Agenda
Village of Arlington Heights
Design Commission
Community Room, 3rd floor
33 S. Arlington Heights Rd. Arlington Heights IL 60005
August 27, 2019
6:30 PM

**Design Commission
8/27/2019**

MINUTES OF
THE VILLAGE OF ARLINGTON HEIGHTS
DESIGN COMMISSION MEETING
HELD AT THE ARLINGTON HEIGHTS MUNICIPAL BUILDING
33 S. ARLINGTON HEIGHTS RD.
AUGUST 13, 2019

B NO. 19039	
DATE: 05-07-19	
DRAWN BY: MDS	
SCALE: AS NOTED	
SHEET NO. FRONT ELEVATION LEFT SIDE ELEV.	2 OF 9

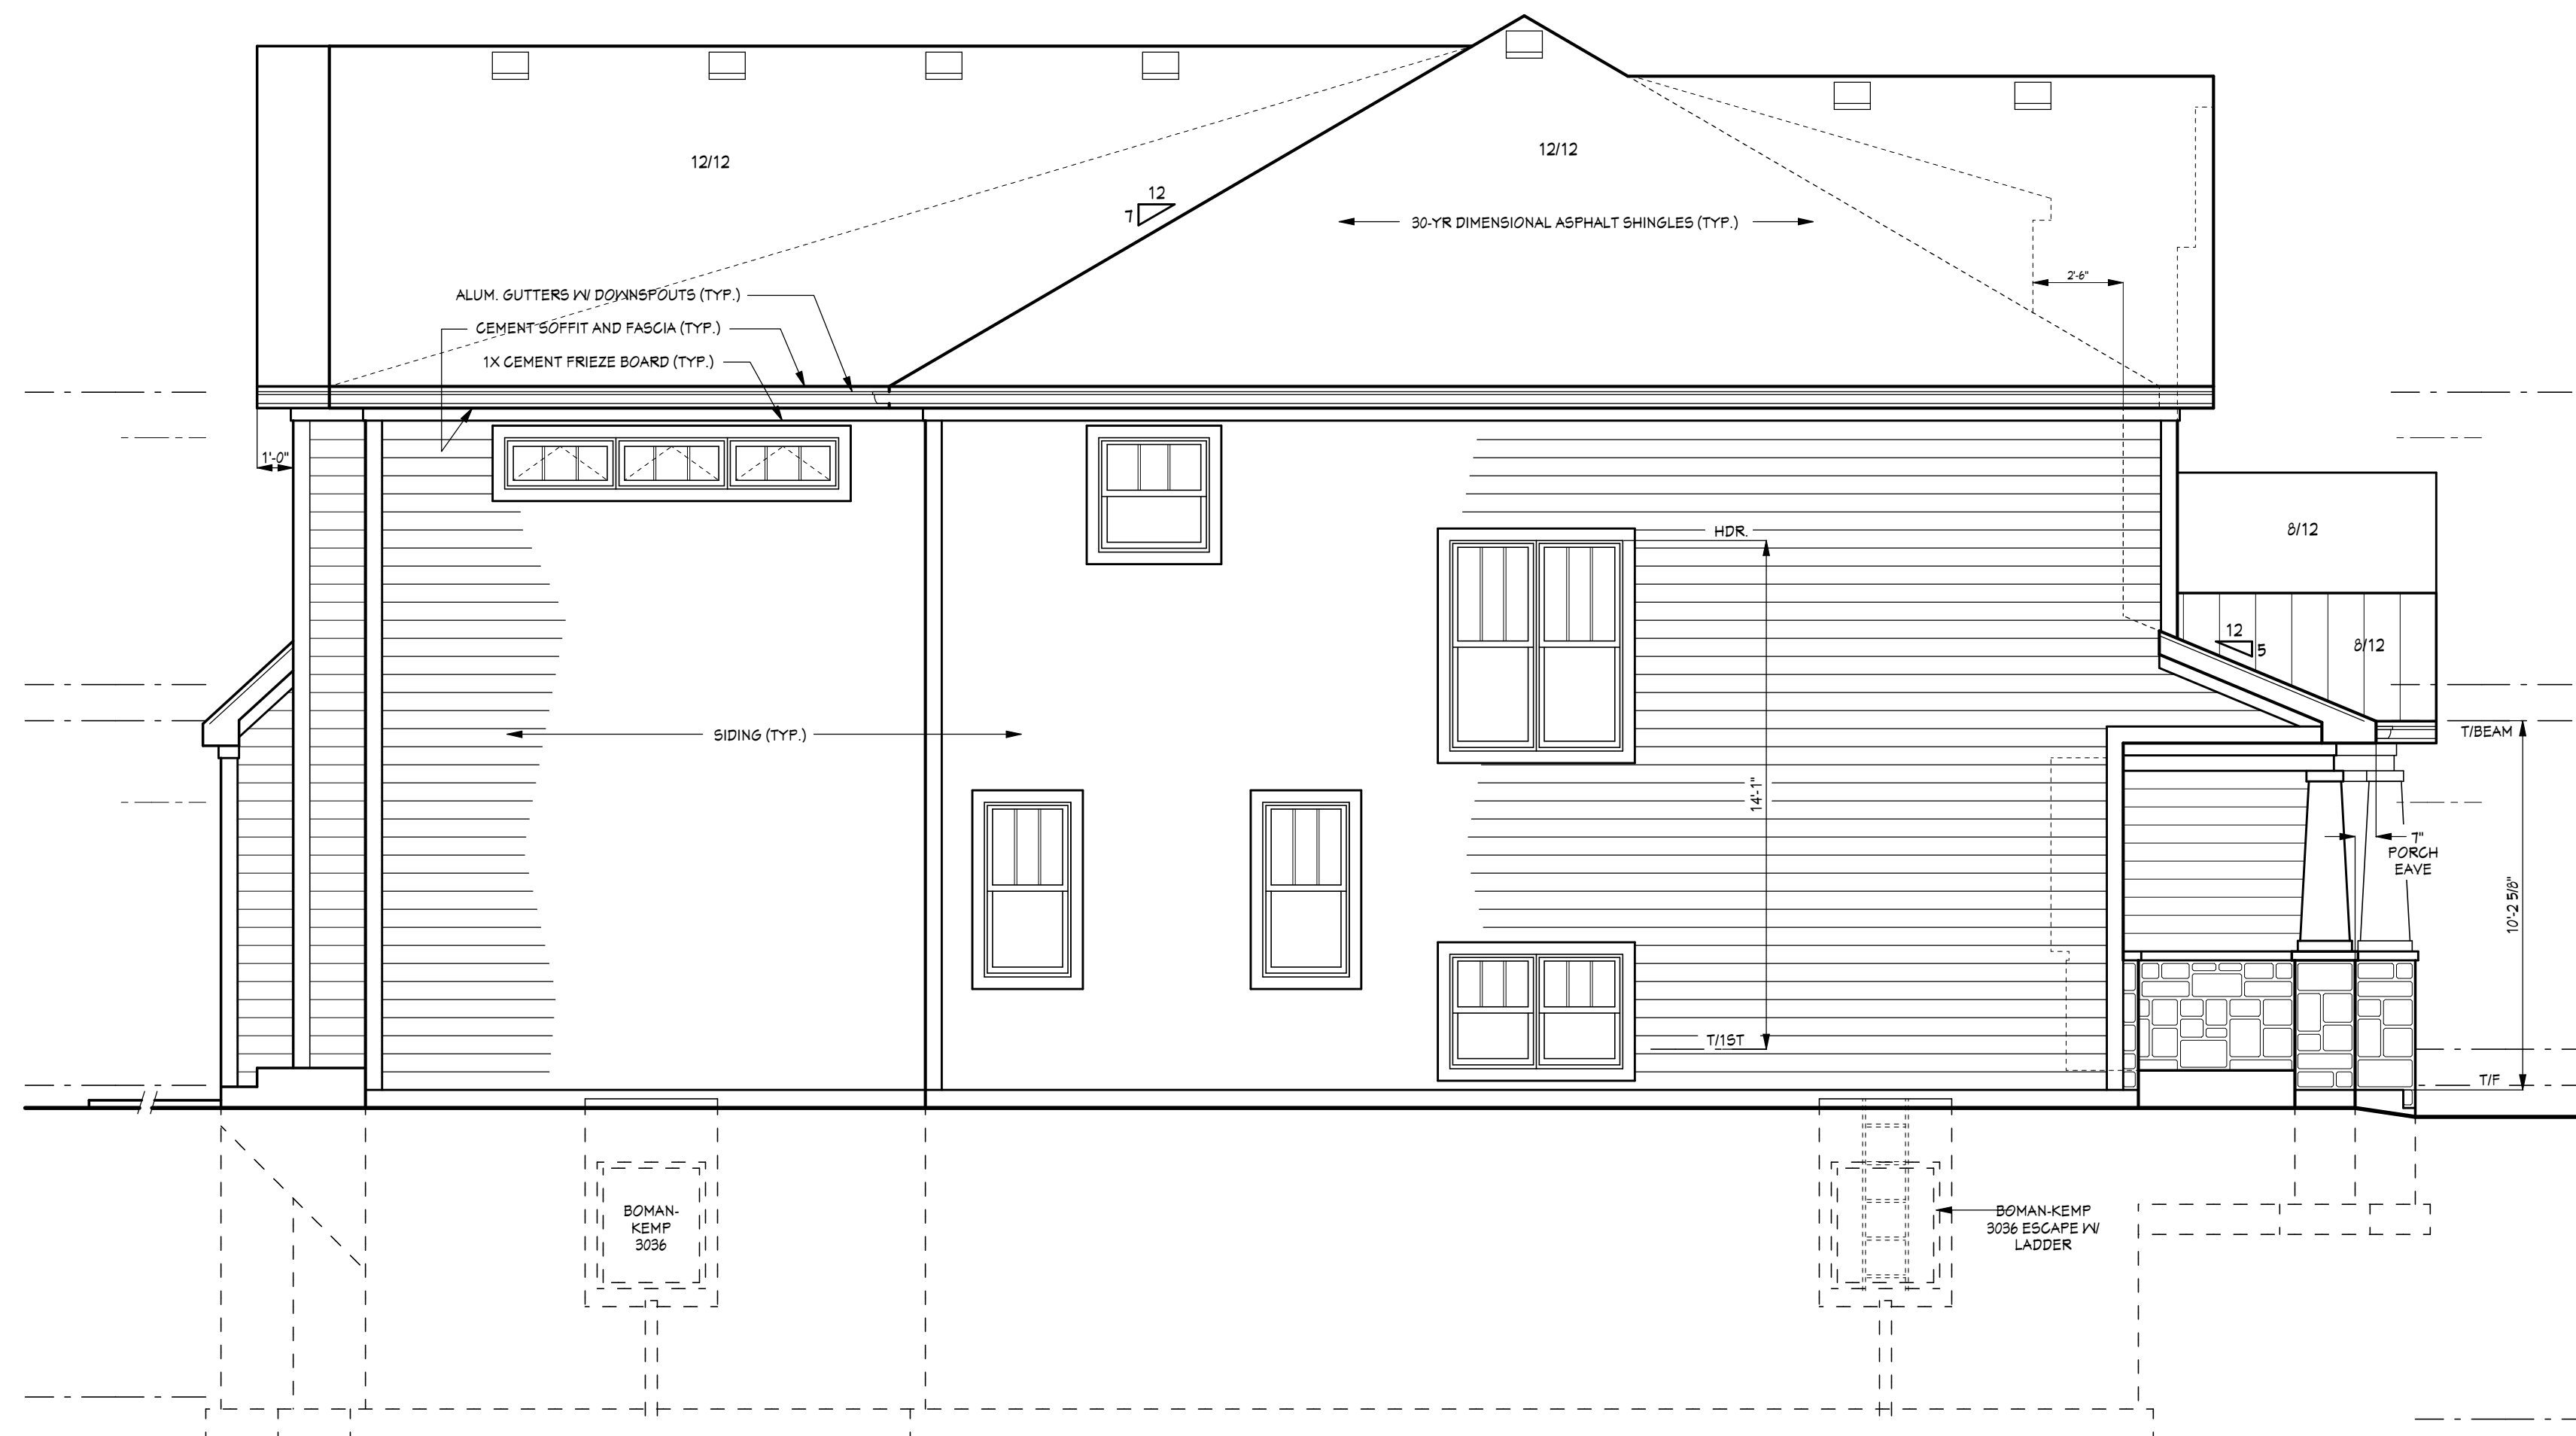
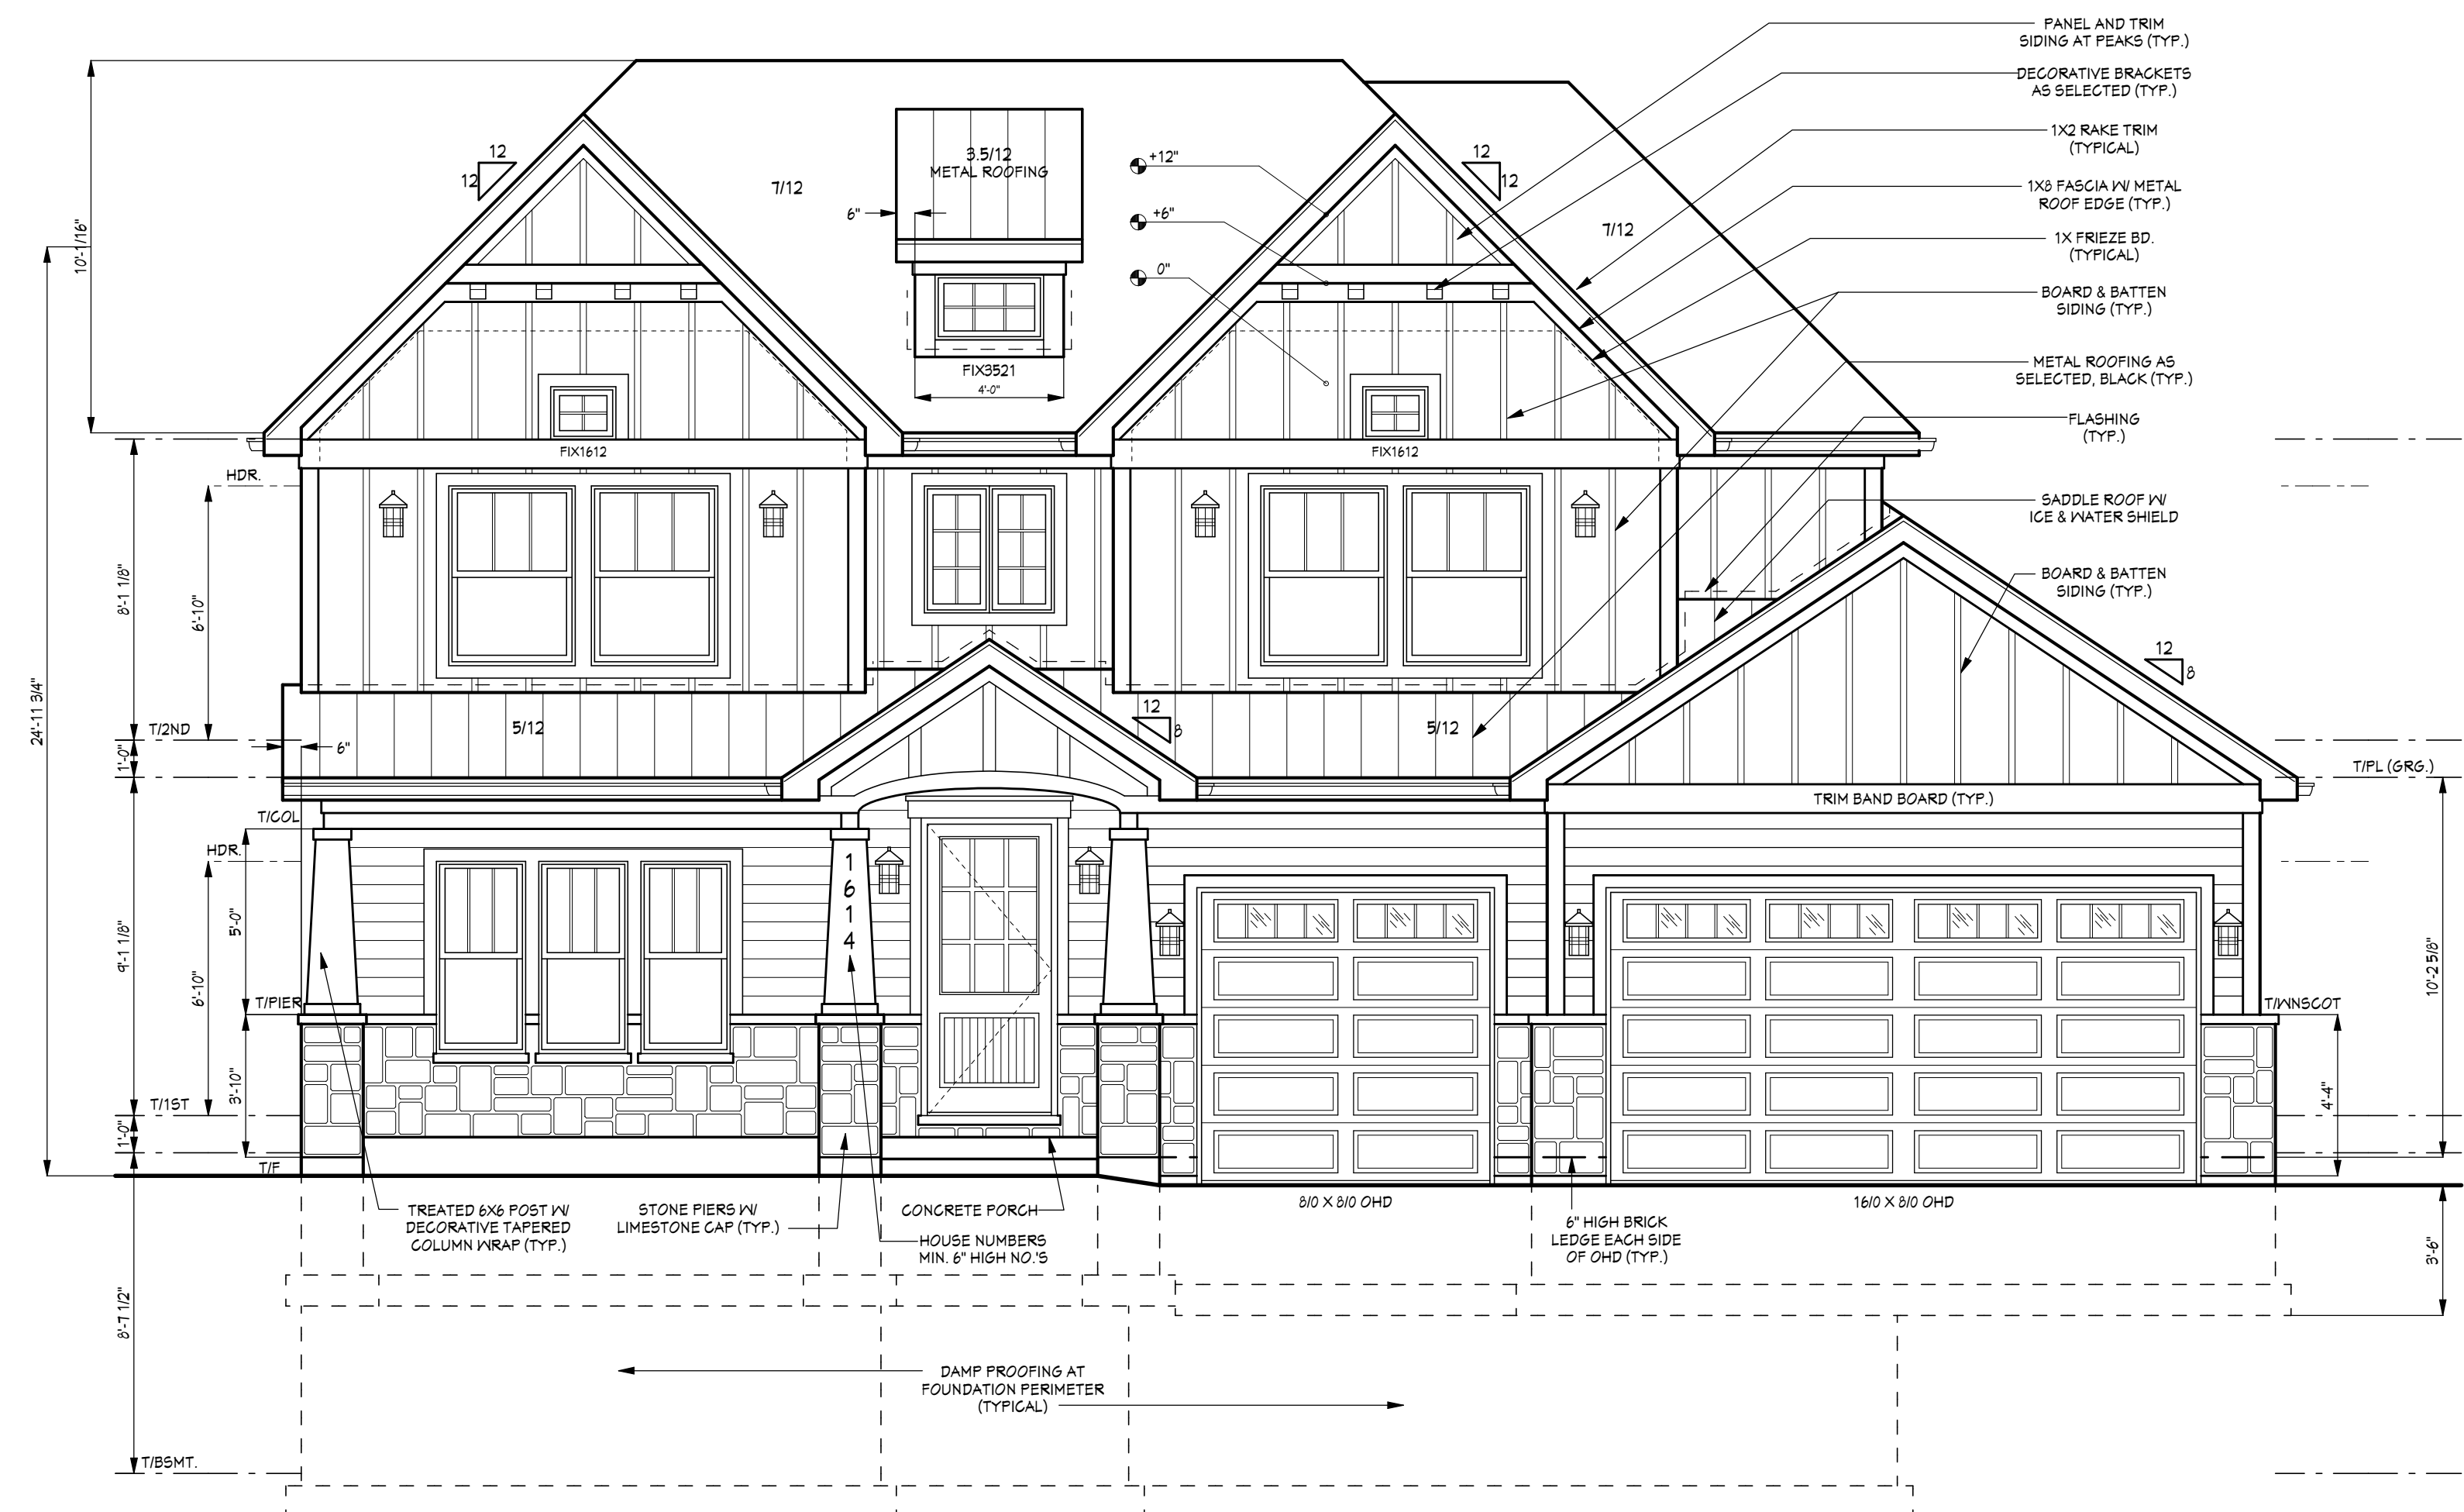
- **Exterior Colors.** The proposed color scheme includes white siding, black roofing, black windows, black fascia/soffits, and black gutters/downspouts. The black fascia/soffits and gutters/downspouts add a bold appearance that will not fit well with the context of the neighborhood.

- o The proposed garage door color is not indicated, but black garage doors would add to the bold contrast in this neighborhood. White garage doors are recommended to blend with the white siding color.

It is recommended that the Design Commission **approve** the proposed new single-family residence to be located at 1614 N. Chestnut Avenue. This recommendation is subject to compliance with the architectural plans received on 7/30/19, and the following:
